# **RYE PARK WIND FARM**

## *Amendments Report No. 2*

*(Development Consent State Significant Development: 6693)*

Document Title: Amendments Report No. 2  
Revision: Final  
Date: 19 March 2021

**Figure 1 Removal and Replacement of Development Corridor North of WTG 39**

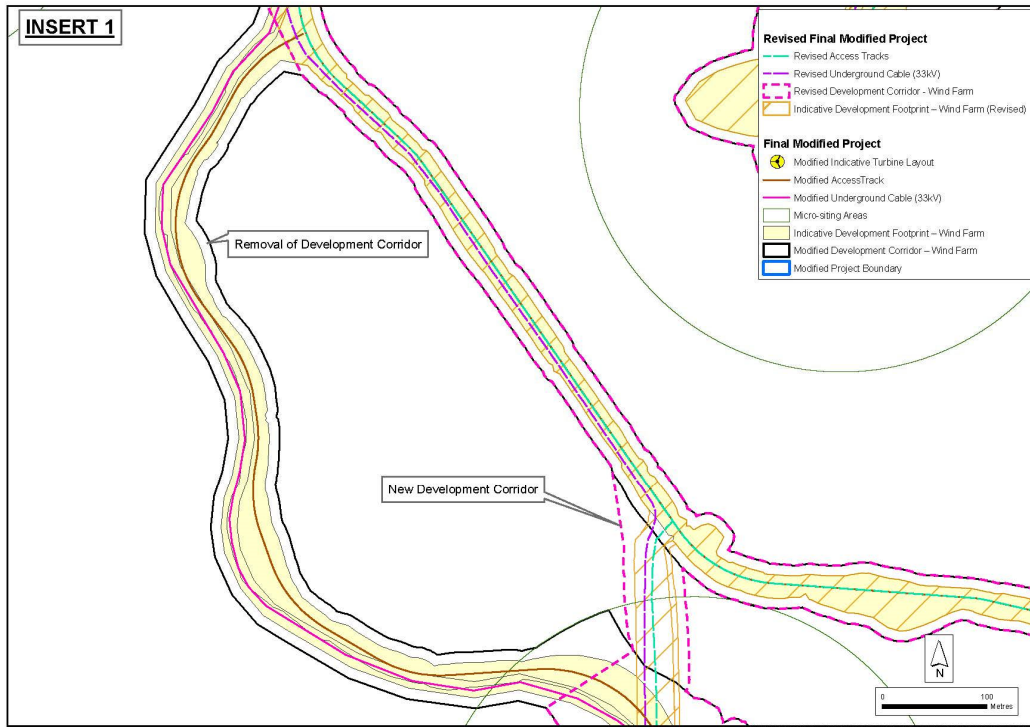
To achieve a safer crossing, particularly regarding sight distance, it is proposed to relocate the crossing 350 m north of the original crossing as shown in Figure 1. As a result of the alternate crossing, 1.70 km of access track is to be repositioned (replacing approximately 1.50 km). The change from the original location to the proposed location will greatly improve road safety for both public road users and Project traffic and will satisfy the SISD criteria.

- Replacement of approximately 1 km access track and cabling north/north west of WTG 39, with a shorter approximately 150 m route (Figure 1).
- Replacement of approximately 4 km of access track running north to south parallel (to the west of) to WTGs 58, 63, 66 and 69 which connected to WTG 51 (Figure 2), with 700 m of connecting access track south of WTG 67 (Figure 3).
- Refinement of development corridor connecting WTGs 58, 63, 66 and 69, reducing overall flexibility and minimising ground disturbance (Figure 2).
- Realignment of approximately 250 m of access track and underground cable north of WTG 128 (Figure 5).
